PARC VISTA (FKA COVINGTON ESTATES) JSP21-47

Public hearing at the request of Toll Brothers, LLC for Preliminary Site Plan with Site Condominium and Stormwater Management Plan. The subject property is in Section 31 north of Eight Mile Road and west of Garfield Road in the RA, Residential Acreage District. The applicant has received City Council approval of a Residential Unit Development (RUD) Agreement on a 54.3 acre parcel to construct 44 single-family residential units.

PLAN REVIEW CENTER REPORT

Review Date: September 8, 2022
Review Type: Preliminary Site Plan
Project Name: JSP21-47 PARC VISTA RUD
Plan Date: August 11, 2022
Prepared by: Lindsay Bell, Planner
Contact: E-mail: lbell@cityofnovi.org; Phone: (248) 347-0484

SECTION 31
TOWN 01 NORTH, RANGE 08 EAST
CITY OF NOV
OAKLAND COUNTY, MICHIGAN
LAYOUT PLAN

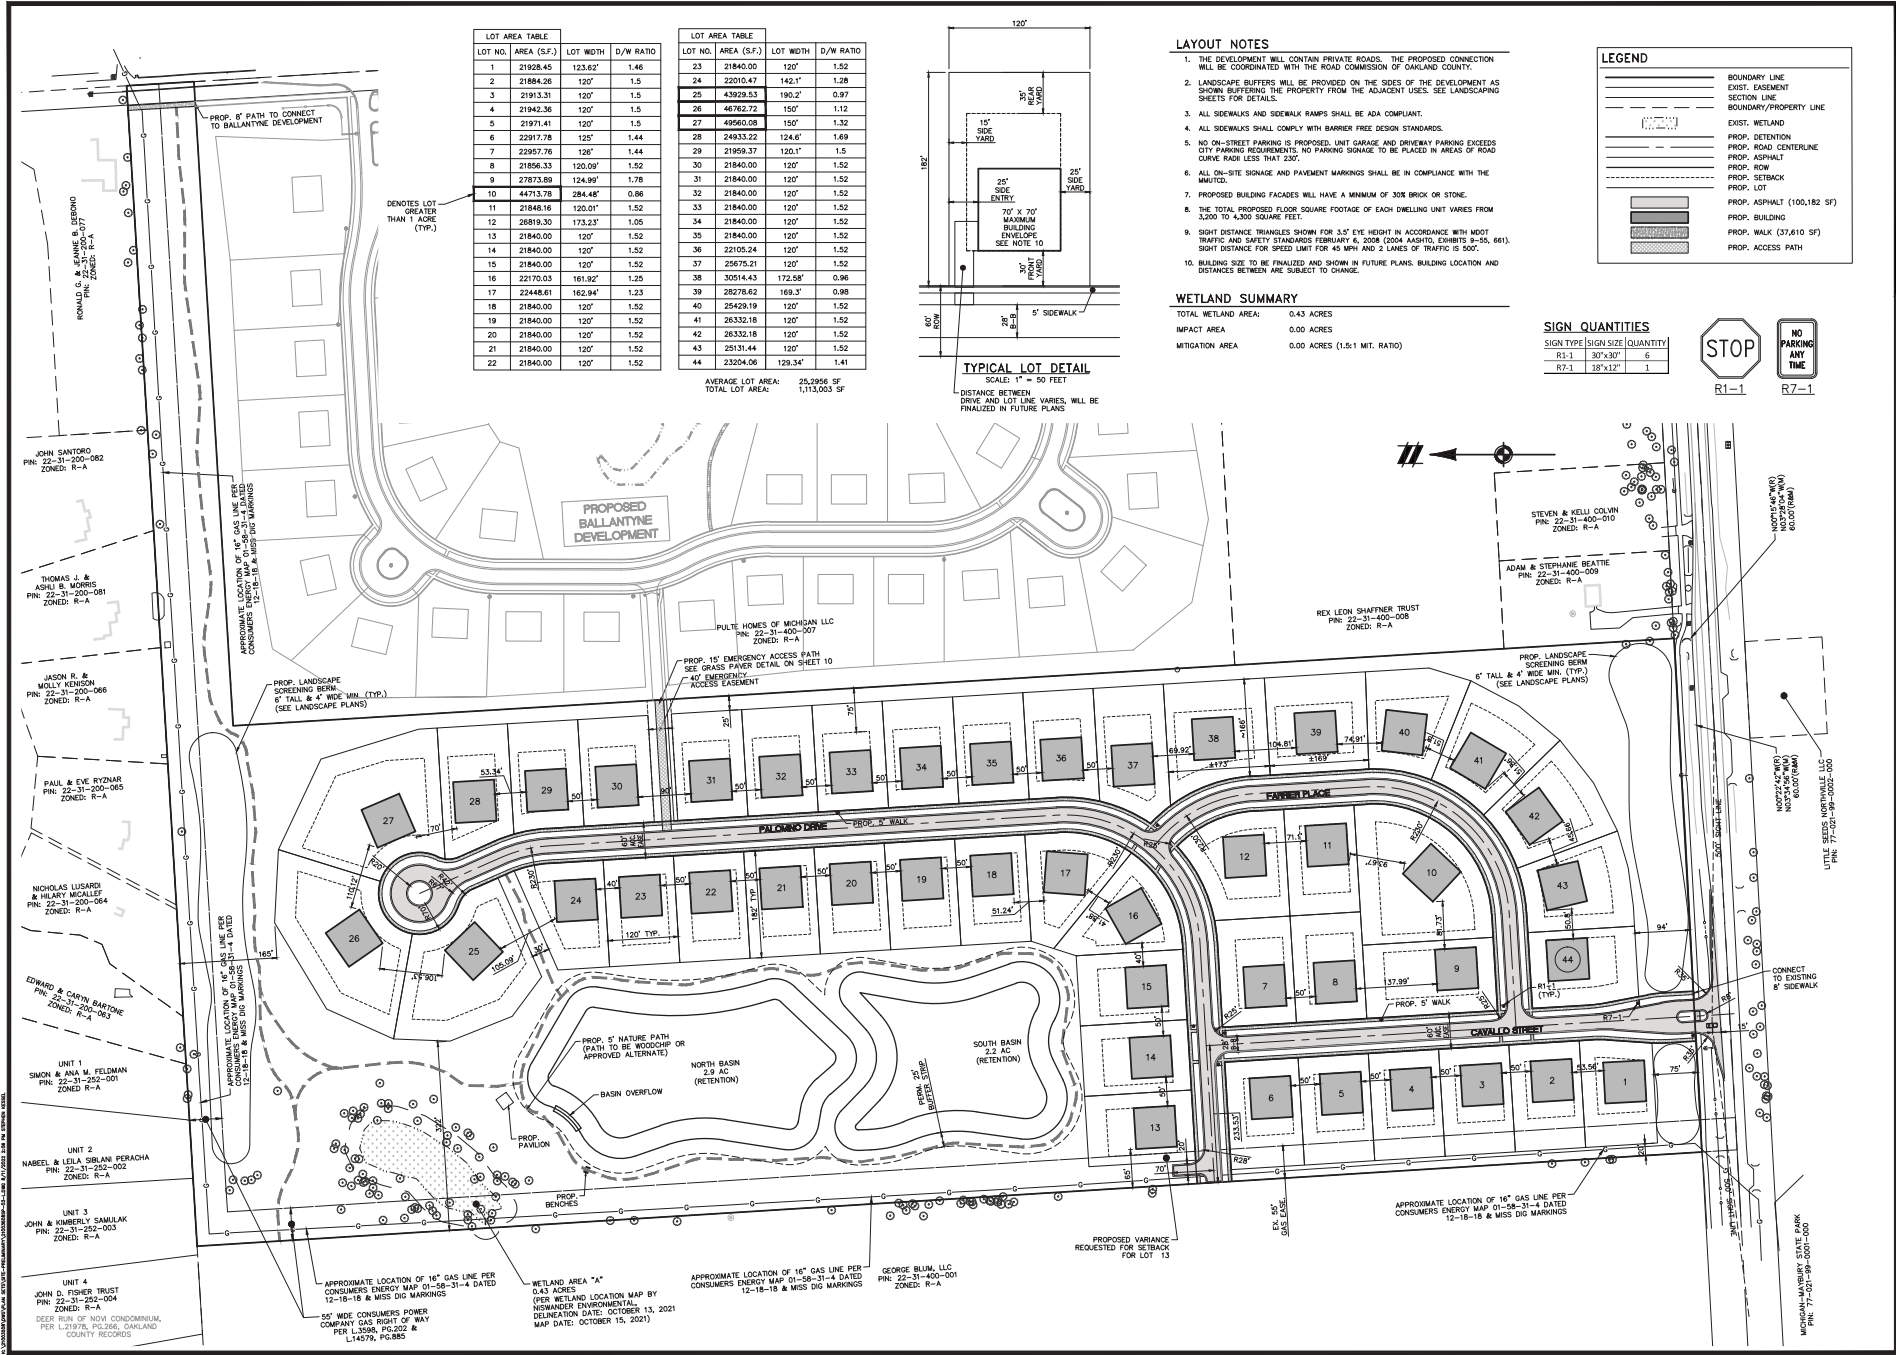
- **All** fire hydrants **MUST** be installed and operational prior to any combustible material is brought on site. **IFC 2015 3312.1**
- **Corrected 8/29/22 KSP**-Emergency access road from the development from the east shall be 20' wide SP sheet #05.

2. Corrected 8/29/22 KSP-Emergency access road from the development from the east shall be 20' wide SP sheet #05.
Response: *The emergency access path currently consists of 15' wide grass paver section and 5' wide concrete walk, totaling a 20' wide path. Please see detail on Sheet 9 of the preliminary site plan.*

Response: *A traffic control sign table is included on Sheet 5. A note is provided in the "Layout Notes" on Sheet 5 stating that the signage shall comply with MMUTCD standards.*

Response: *The Typical Lot Detail is shown on Sheet 5 of the preliminary site plans to provide detail of the proposed driveways. Individual driveways and tapers will be shown on the Final Site Plan.*

Response: *A gate will be added along the right-of-way of the emergency access path at Lexington Drive and the specified detail will be added to the plans on the Final Site Plan. The gate at the other end of the emergency access will be accommodated by the Ballantyne development to the east, as depicted on Sheet 5 of the preliminary site plans.*

TOLL BROTHERS
 PARC VISTA
 PRELIMINARY SITE PLAN
 STORM WATER MANAGEMENT PLAN

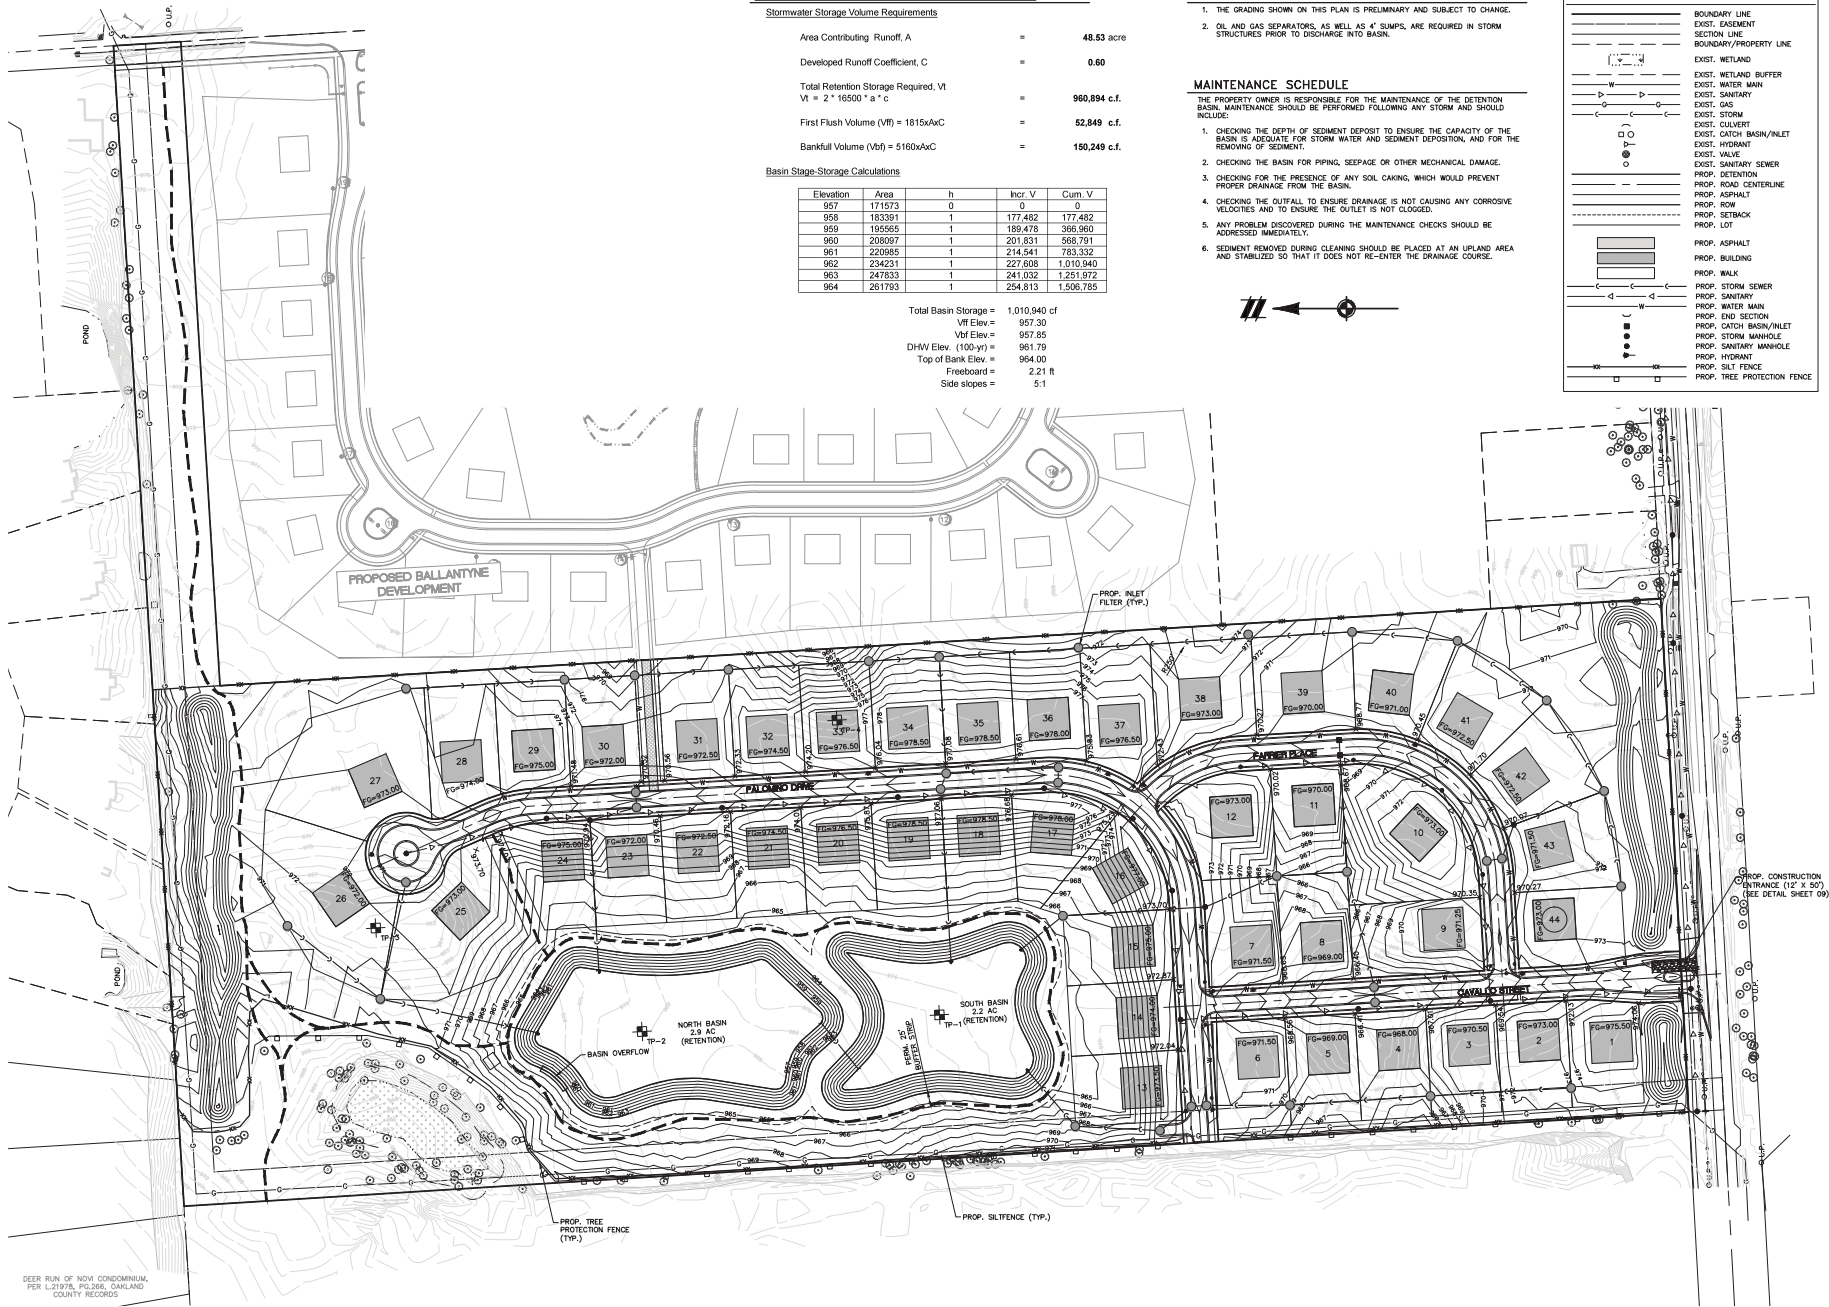
54. Stormwater retention facilities must provide sufficient storage capacity for 2 consecutive 100-year storm events.
Response: *The proposed design of the retention facilities currently accounts for 2 consecutive 100-year storm events. Our calculations are included on Sheet 7 of the preliminary site plans.*

Response: *Pretreatment will be provided prior to discharge into the basin as requested. It is currently indicated on Sheet 7 of the preliminary site plan and will also be depicted in the profiles of the Final Site Plan.*

Response: *The current design includes 2.21 feet of freeboard. Please see the storm water calculations on Sheet 7 of the preliminary site plan.*

Figure 1

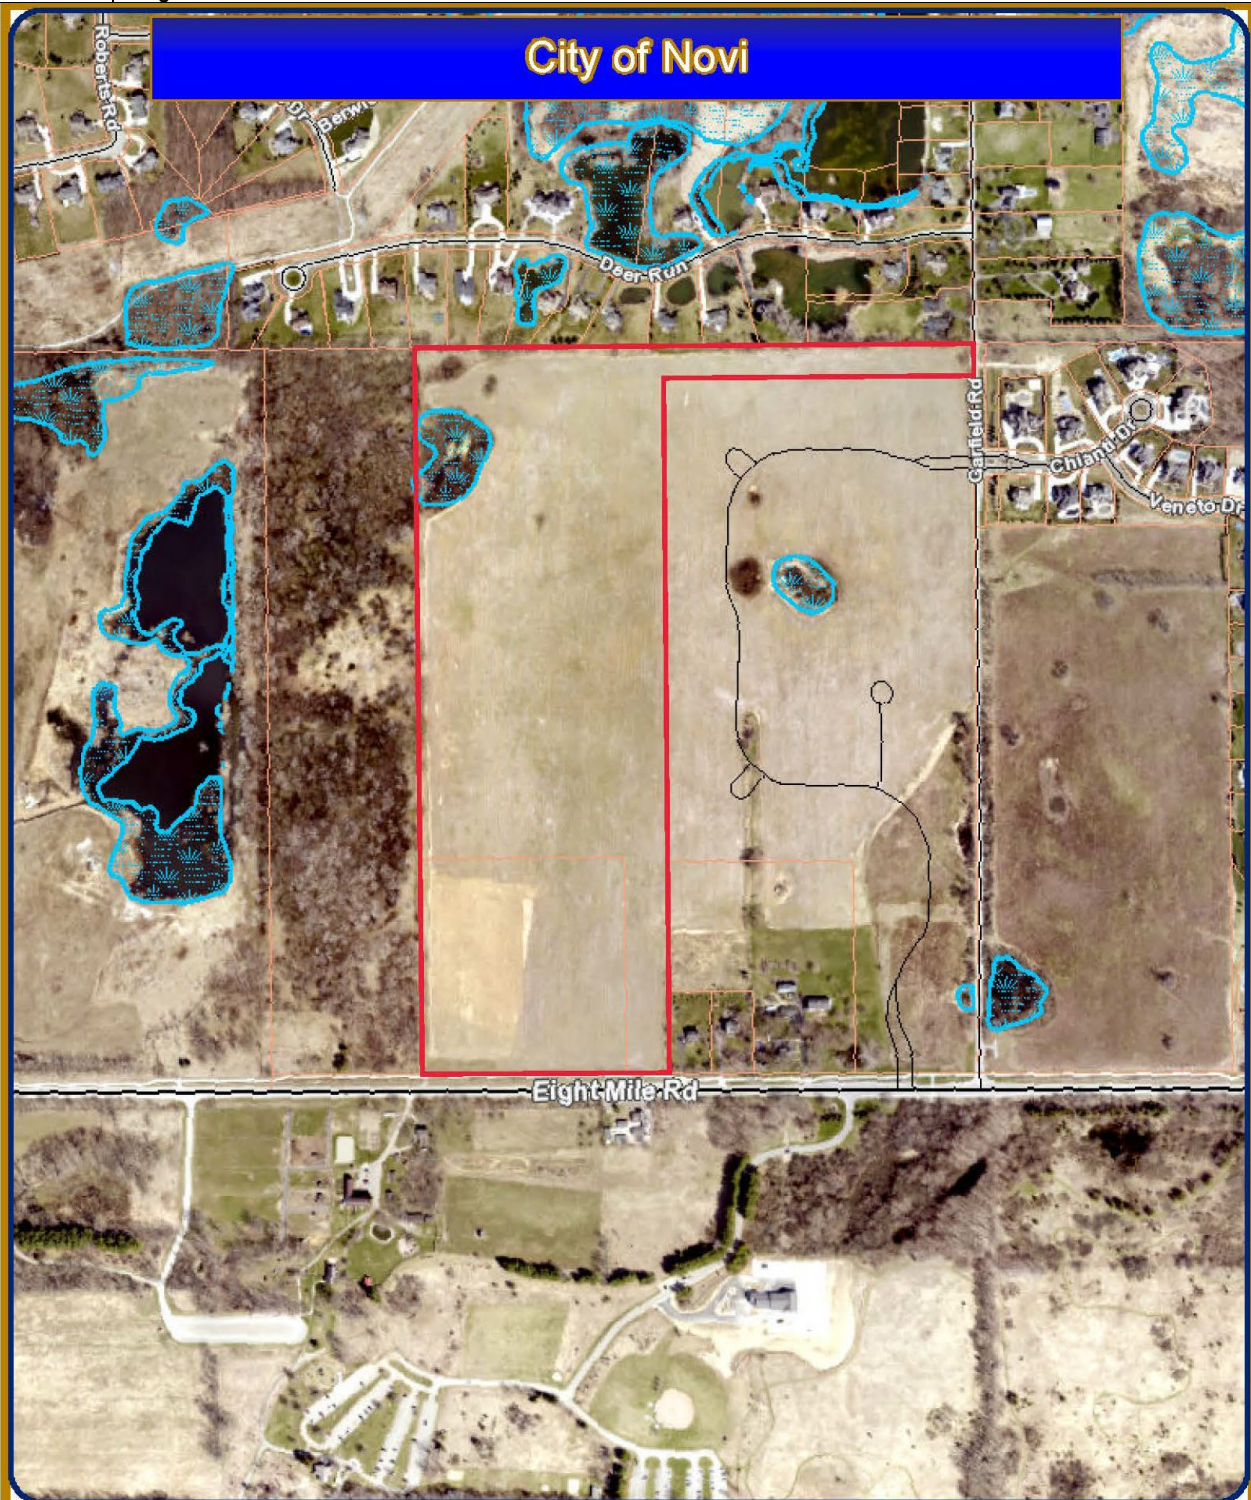
MSG reviewed The City of Novi Wetlands Maps and the Michigan Department of Environment, Great Lakes, and Energy (EGLE) Wetlands Map Viewer for the Site. The Site contains City-regulated wetlands (Figure 1). The Site also contains wetlands as identified on National Wetland Inventory (NWI) and Michigan Resource Inventory System (MIRIS) maps (Figure 2). NWI and MIRIS wetlands are identified through interpretation of topographic data and aerial photographs by the associated governmental bodies.

Figure 1. Parc Vista site
City of Novi Regulated Woodland Map
(Light green hatched areas are regulated woodlands)

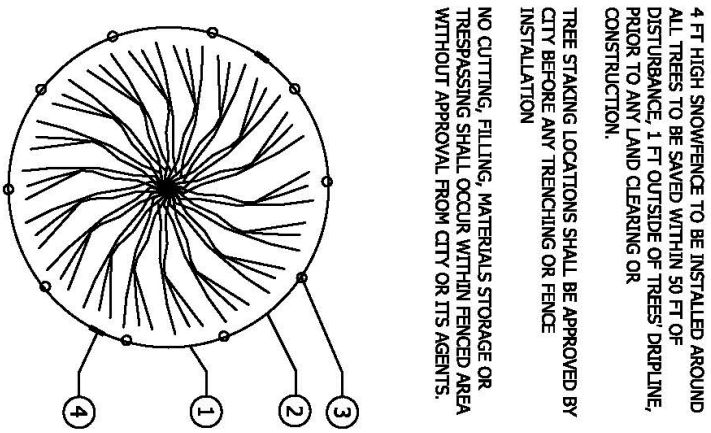
The site contains a small area of City of Novi regulated woodlands in the northwest corner of the site. The trees and woodlands on the site are a mix of floodplain and upland species, including boxelder, black cherry, black walnut, shagbark hickory, and American elm; and invasive species including common buckthorn and tree of heaven.

The development **proposes to preserve the regulated woodland** and remove the following three non-regulated trees that are outside of the woodland.
